**TB 1-1520-248-30-05**

CHANGE  
NO. 2

**INTERMEDIATE WEIGHT REDUCTION IMPLEMENTATION  
ON OH-58D HELICOPTERS**

### **INTERMEDIATE WEIGHT REDUCTION IMPLEMENTATION ON OH-58D HELICOPTERS**

Figure 1

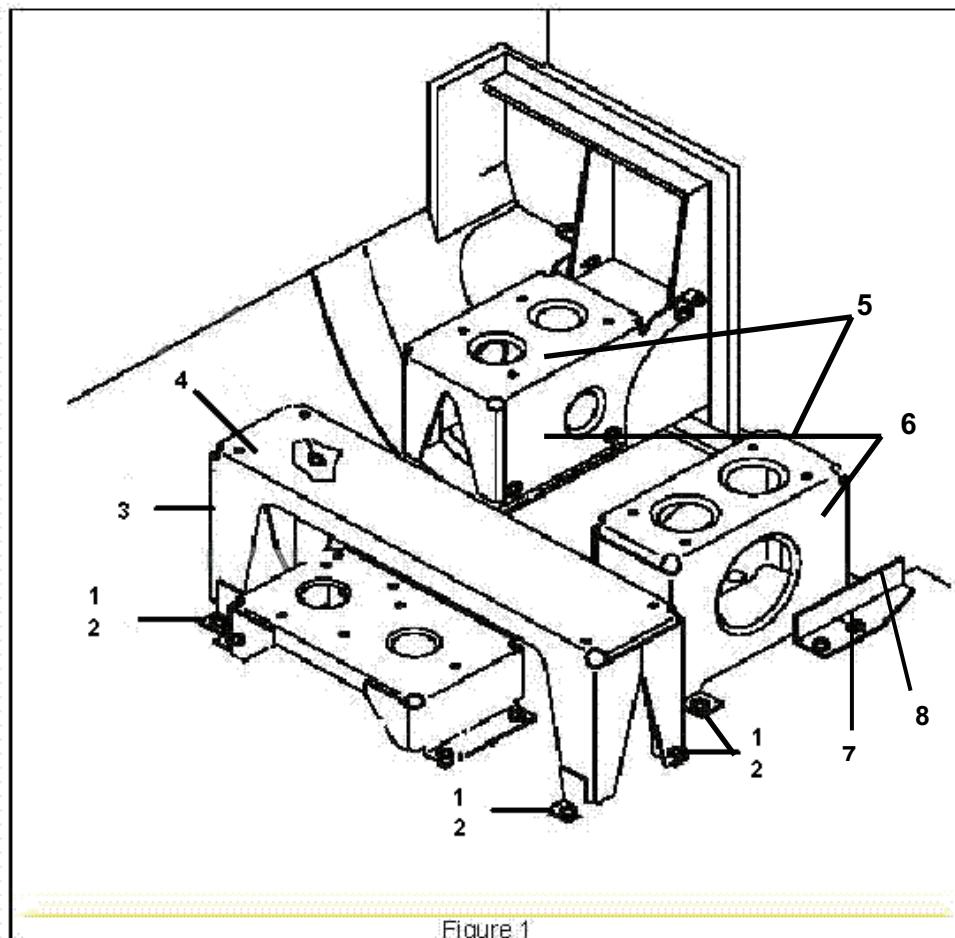
- a. Removal of the HF- R/T Shock Mount. (See Figure 1.)

- (1) Remove right Avionics door.
- (2) Remove four machine screws (1) and four flat washers (2) holding the HF R/T Hard Mount (3) in place.
- (3) Remove HF-R/T shock mount (4) and Hard Mount (3). Disconnect wiring bundles from side of HF-RT Hard Mount.
- (4) Reinstall four machine screws (1) and four flat washers (2) in mounting holes.

b. Removal KY-75 Shock Mount. (See Figure 1.)

- (1) Remove four machine screws (1) and four flat washers (2).
- (2) Remove rivets (7) and "L" shaped bracket (8).
- (3) Remove KY-75 Shock Mount (5) and Brackets (6).
- (4) Reinstall four screws (1) and four washers (2) in mounting holes.

Figure 2

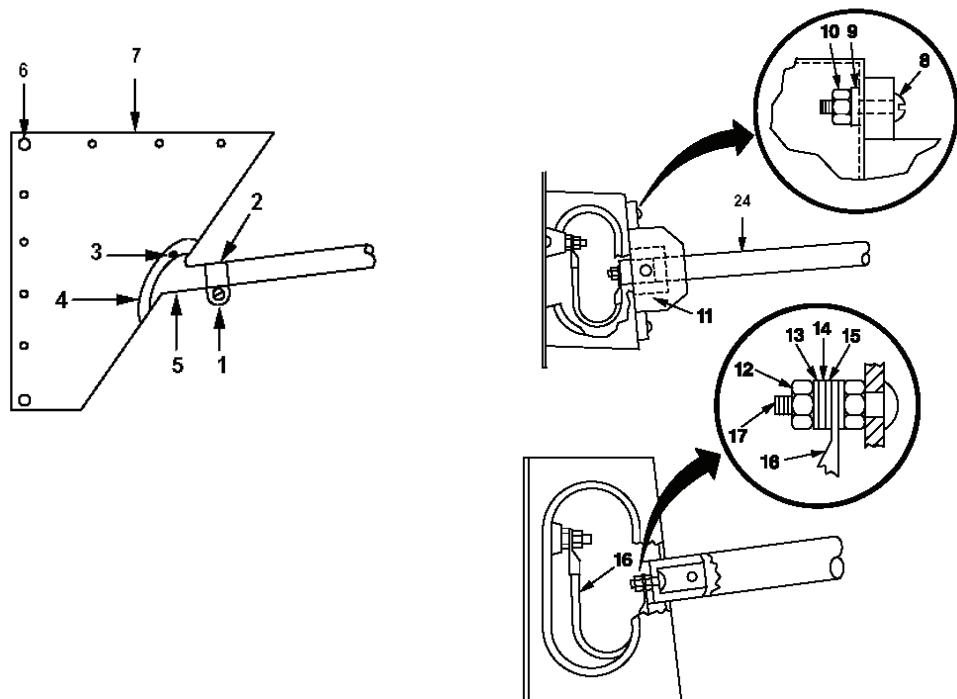
- (7) Insert Episeal 10-10 (Metal Set or equivalent) through tape using syringe.
  - (8) Sand area after drying.
- c. Removal HF Antenna. (If Installed.) (See Figure 2.)
- (1) At rear of fuselage loosen screw (1) on clamp (2).
  - (2) Remove 3 screws (3).
  - (3) Slide ring (4) and boot (5) toward rear of tailboom.
  - (4) Remove 18 screws (6) from access door (7).
  - (5) Slide access door (7) toward rear of tailboom.
  - (6) Remove four screws (8), washers (9) and nuts (10) from insulator (11).
  - (7) Slide insulator (11) toward rear of tailboom.
  - (8) Remove nut (12), washer (13), lockwasher (14) and washer (15).
  - (9) Remove jumper assembly (16) from antenna terminal (17). Retain hardware.

Figure 3

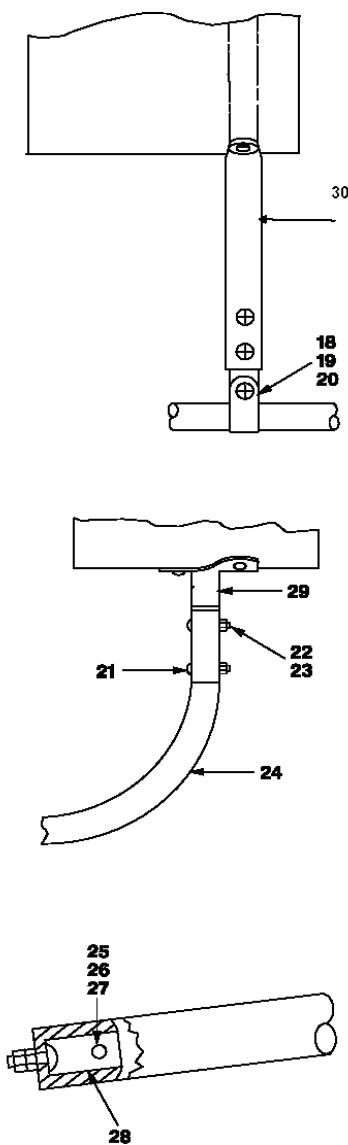
- (10) Remove screw (18), washer (19) and nut (20). (See Figure 3.)
- (11) Remove two screws (21), washers (22) and nut (23).
- (12) Remove HF antenna (24) from helicopter.
- (13) Remove screw (25), washer (26) and nut (27) from fitting (28) at fuselage end of antenna (24).
- (14) Remove rear support (29) and center support (30) and reinstall screws.
- (15) Remove insulator (11), access door (7), boot (5), ring (4), and clamp (2) from antenna (24).

(16) Fabricate a cover plate from 2024 sheet stock using ring (4) from access panel (7) as a template.

(17) Prime using MIL-PRF-23377 epoxy primer and paint the cover plate.

(18) Install the cover plate using the existing screws onto access panel (7).

Figure 4

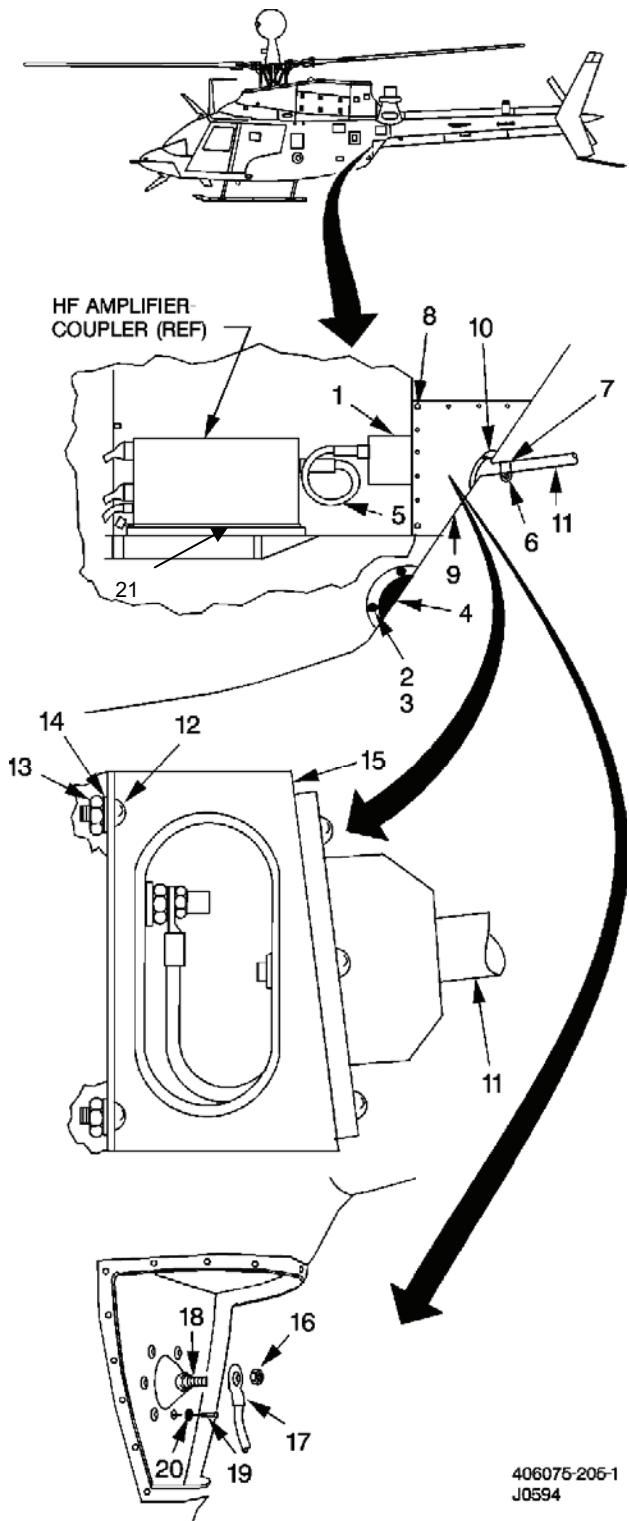
- d. Removal of HF-Antenna Coupler. (If installed.) (See Figure 4.)
  - (1) Gain access to HF antenna coupler (1) by removing four screws (2), washers (3), and exhaust port screen (4).
  - (2) Disconnect RF cable (5) from HF antenna coupler (1).
  - (3) Remove four screws (12), nuts (13), and washers (14) from bracket (15).
  - (4) Remove jamnut (16) and jumper assembly terminal (17) from stud (18).
  - (5) Support HF antenna coupler (1) and remove six mounting screws (19) and washers (20).
  - (6) Open aft electrical compartment door and remove HF antenna coupler (1).
- e. Removal of the HF - Amplifier Coupler Mounting Rack. (See Figure 4.)
  - (1) Gain access to the aft electronics bay.
  - (2) Remove screws attaching the mounting rack (21) to the airframe structure.

Figure 5

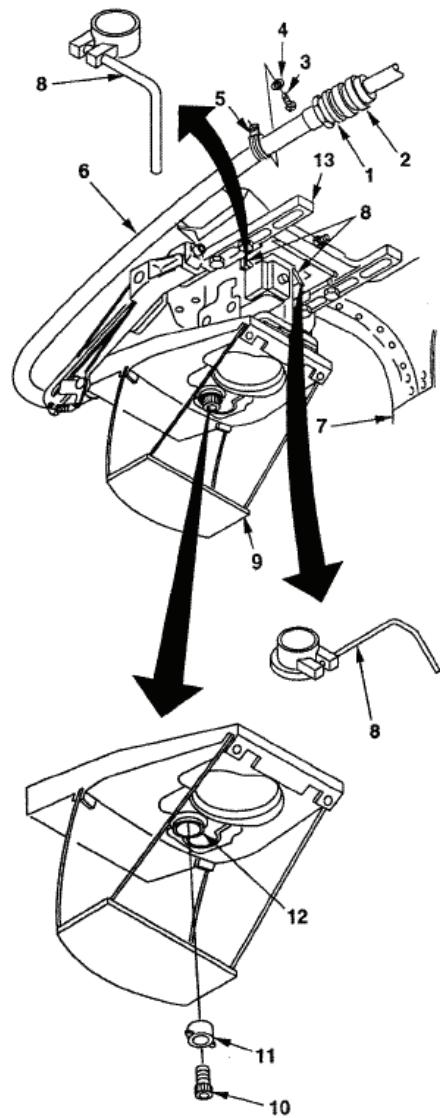
f. Removal of the PDU. (If installed.) (See Figure 5.)

- (1) Disconnect electrical connector (1) from helicopter disconnect (2).
- (2) Remove screw (3), washer (4), and clamp (5) securing PDU electrical cable (6) to cockpit overhead (7).
- (3) Loosen height adjustment lock release levers (8) and adjust PDU (9) to gain access to cap screw (10) and down stop (11).
- (4) Lock PDU (9) in position.
- (5) Remove cap screw (10) and down stop (11) from front mount post (12).
- (6) Loosen height adjustment lock release levers (8) and remove PDU (9) from mount assembly (13).

Figure 6

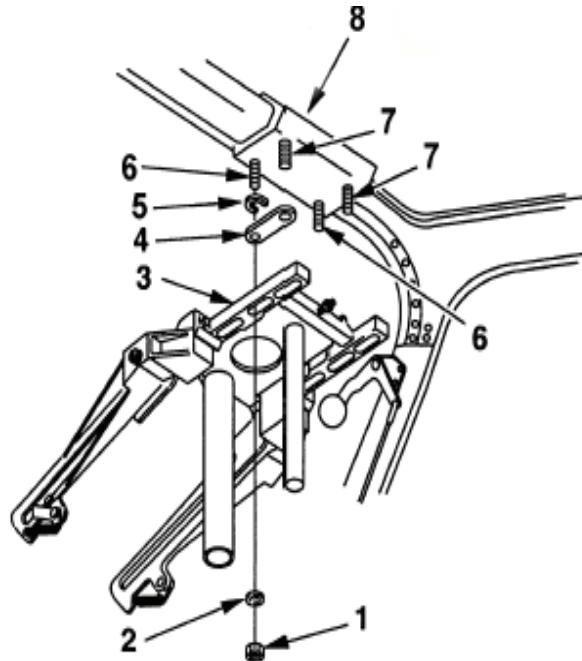
g. Removal of Pilot Display Unit (PDU) Mount Assembly. (See Figure 6.)

(1) Remove four nuts (1) and washers (2) securing mount assembly (3), spacers (4), and shims (5) to forward studs (6) and aft studs (7) on PDU fitting (8).

(2) Remove mount assembly (3), spacers (4), and shims (5) from forward studs (6) and aft studs (7).

(3) Remove the studs (6 and 7) from the PDU Fitting by cutting with a grinder, leaving a small portion of the stud protruding. File remainder of stud level to surface of mount.

- (4) Clean smoothed surface of stud using isopropyl alcohol.

- (5) Prime area using MIL-PRF-23377 epoxy primer and paint.
- (6) Gain access to the right passenger side area.
- (7) Remove the Pilot PDU cable by removing 5 standoffs.

Figure 7

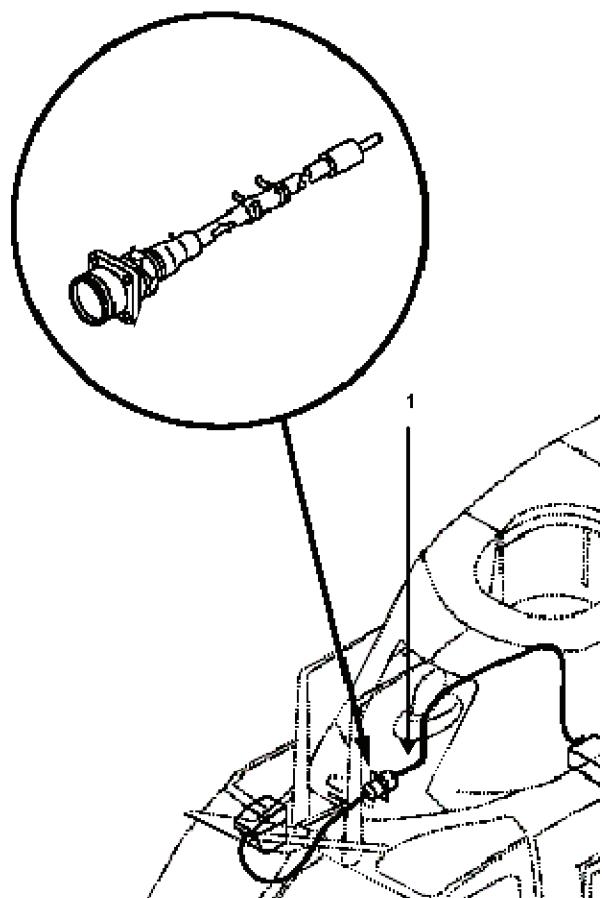
h. Removal of the PDU Cable. (See Figure 7.)

- (1) Gain access to the right side electronics bay and to the pilot area.
- (2) Remove the machine screws and standoffs securing the PDU cable.
- (3) Remove the PDU Cable.
- (4) Remove PDU Cable Bracket (1) held in by 4 rivets.
- (5) Cut off clamp studs on back door frame.

Figure 8

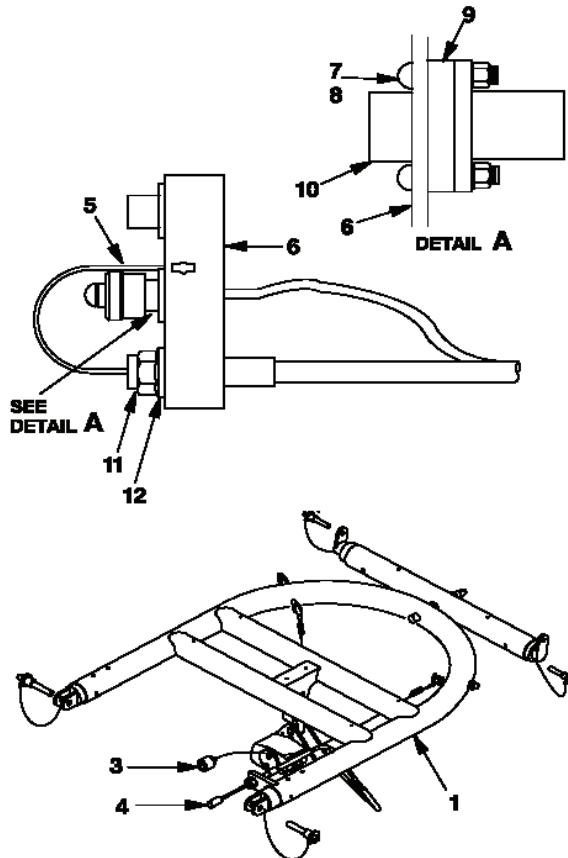
- i. Remove Cargo Handle, Cables. (See Figure 8.)

- (1) Cut cable and electrical wire for emergency release where they enter the lower fuselage.
- (2) Remove rear center console panel under collective.
- (3) Locate and remove cargo release wiring. (See Figure 10, Item 32.)
- (4) Remove bracket assembly (6) and reinstall screws.

Figure 9

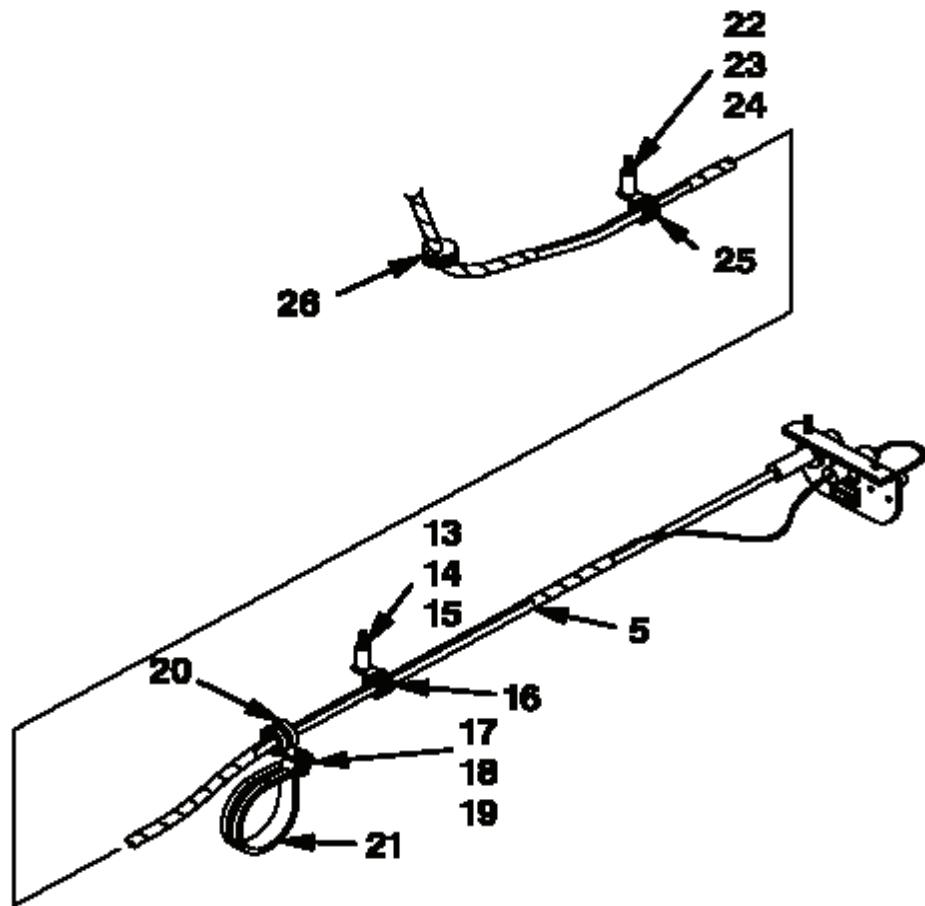
- (5) Remove screw (13), washer (14), and spacer (15). (See Figure 9.)
- (6) Remove clamp (16) from cable assembly (5).
- (7) Remove nut (17), washer (18), and screw (19).
- (8) Remove clamp (20) from cable assembly (5).
- (9) Remove clamp (21) from forward crosstube.
- (10) Remove screw (22), washer (23), and spacer (24).
- (11) Remove clamp (25) from cable assembly (5).
- (12) Remove grommet (26) from bottom of fuselage.

Figure 10

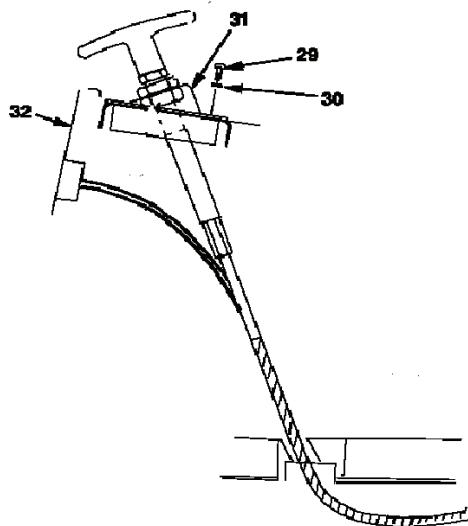
(13) Remove three screws (29) and three washers (30) securing mount (31) to console (32). Remove mount and cable. (See Figure 10.)

(14) Fabricate a cover plate from 2024 sheet stock to cover area on center console.

(15) Prime with MIL-PRF-23377 epoxy primer and paint the fabricated cover plate.

(16) Attach cover plate to center console using screws removed earlier.

Figure 11

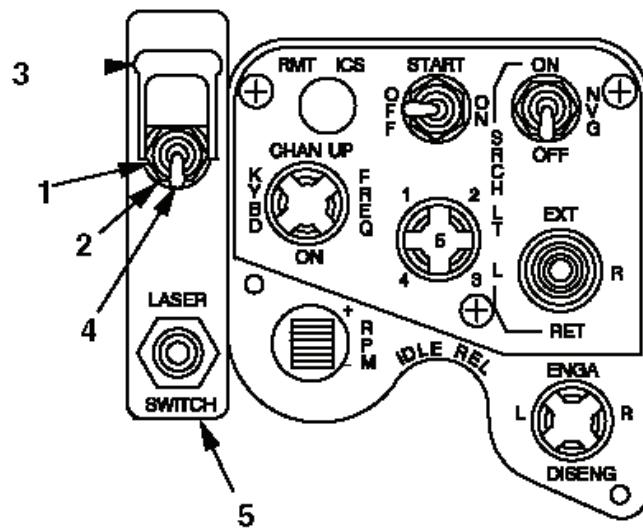
j. Remove Cargo Release Switch. (See Figure 11.)

- (1) Cut wires connected to cargo release switch.
- (2) Remove nut (1), washer (2), and switch guard (3) from cargo release switch (4).
- (3) Remove cargo release switch (4) from switch support (5).
- (4) Cut shrink-wrap approximately 1/2 inch to expose cargo wires where they enter the collective.
- (5) Cut and cap wires and recover with existing shrink-wrap.
- (6) Fabricate a cover plate from 2024 sheet stock to cover area on switch support (5).

- (7) Prime using MIL-PRF-23377 epoxy primer and paint the cover plate.
- (8) Attach cover plate to switch support (5) using rivets (NSN 5320-00-269-9400).

Figure 12

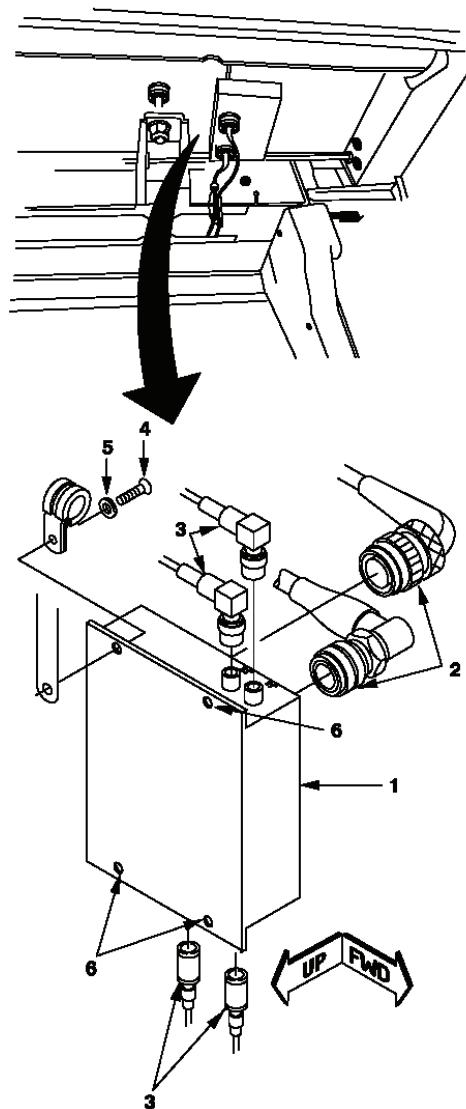
- I. Remove FM Comparator. (See Figure 12.) (CDS2 aircraft)
  - (1) Gain access to comparator (1) on inside roof of helicopter.
  - (2) Disconnect two electrical connectors (2) and four coax connectors (3) from comparator (1).
  - (3) While supporting comparator (1), remove one screw (4) and washer (5).
  - (4) Loosen three captive screws (not shown) (6) and remove comparator (1) from helicopter.
  - (5) If ARC201 radio is installed, remove stand-off coupler 2304A3.
  - | (6) Replace connector (2304Z2P5) on cable (2ARC186-103A(7)) with new connector (part number M39012/17-0502, NSN 5935-01-046-2037).
  - (7) Remaining coax cables will be removed from helicopter during removal of FM Antenna Coupler in step m.
  - (8) Retain and secure electrical connectors.

Figure 13

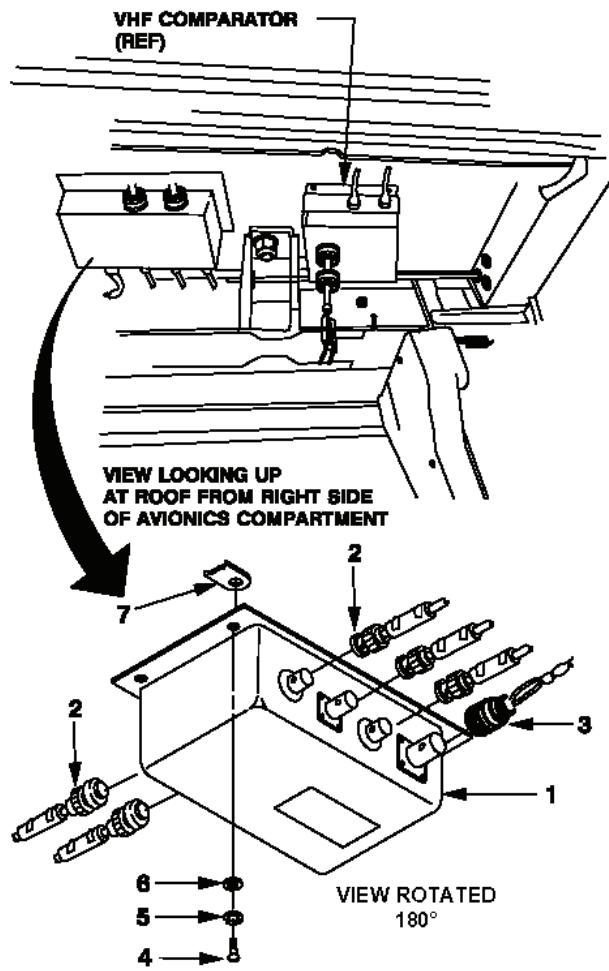
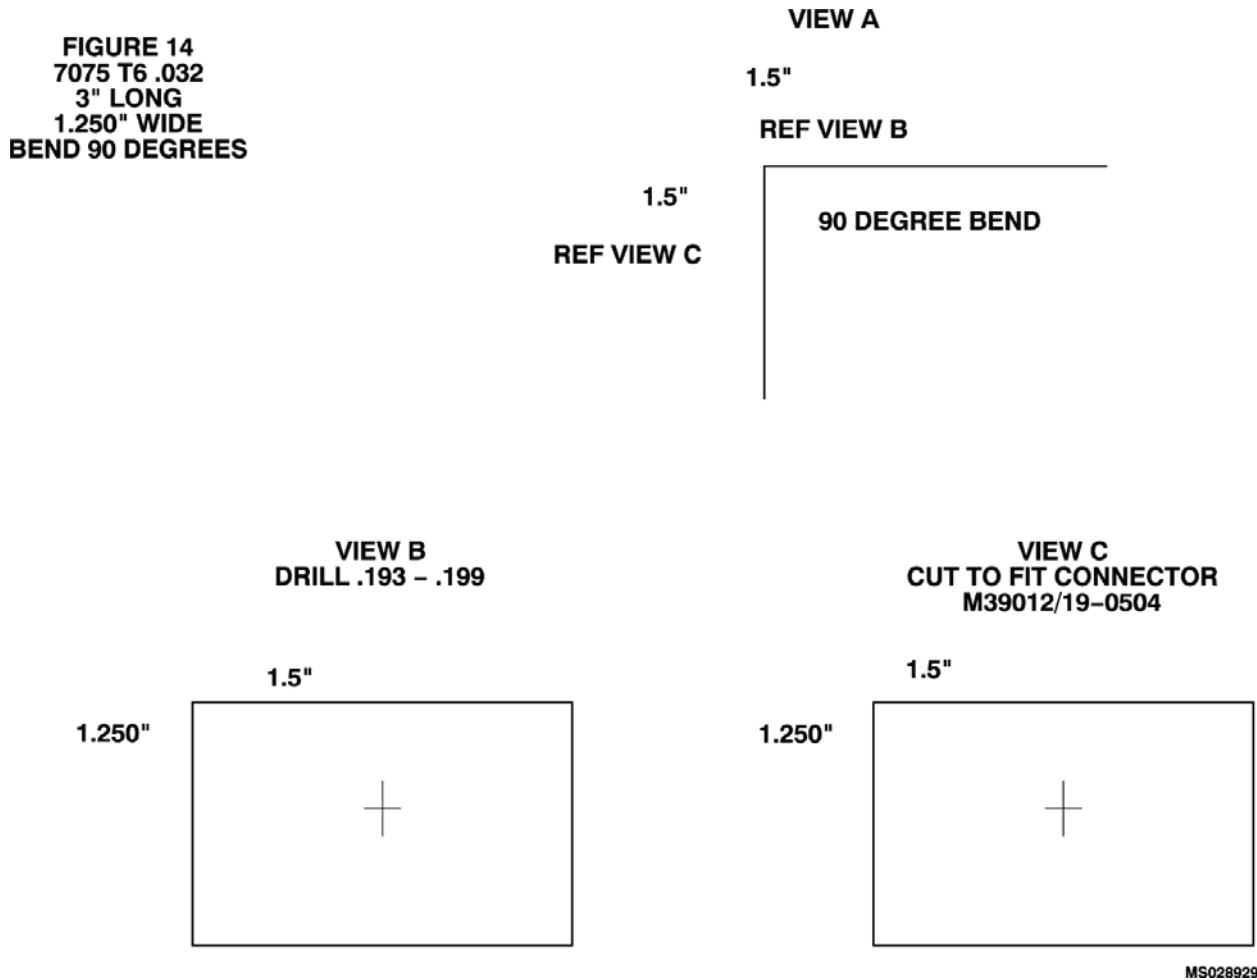
m. Remove FM Antenna Coupler (See Figure 13.) (CDS2 aircraft)

- (1) Disconnect five coax connectors (2) from antenna coupler (1).
- (2) Disconnect electrical connector (3) from antenna coupler (1).
- (3) Retain and secure electrical connector.
- (4) Support antenna coupler (1) and remove four screws (4), lockwasher (5), and washers (6). Retain for later use.
- (5) Remove antenna coupler (1) from helicopter.
- (6) Remove the three coax cables (2ARC186-34A, -35A, and -36A) between coupler and comparator.
- (7) Disconnect cable from L/H homing antenna, and remove cable 2 ARC 186-39A from coupler to antenna.

- | (8) Fabricate angle bracket from 0.032 inch 7075T6 aluminum IAW figure 14. Treat IAW TM 1-1500-204-23 and paint to match interior of cabin.

| (9) Using one of each retained screw (4), lockwasher (5) and washer (6), install fabricated angle bracket in cabin roof at forward right insert previously used by coupler.

| (10) Install new connector (part number M39012/17-0502).

| (11) Attach 2304Z2P2 to new connector on angle bracket.
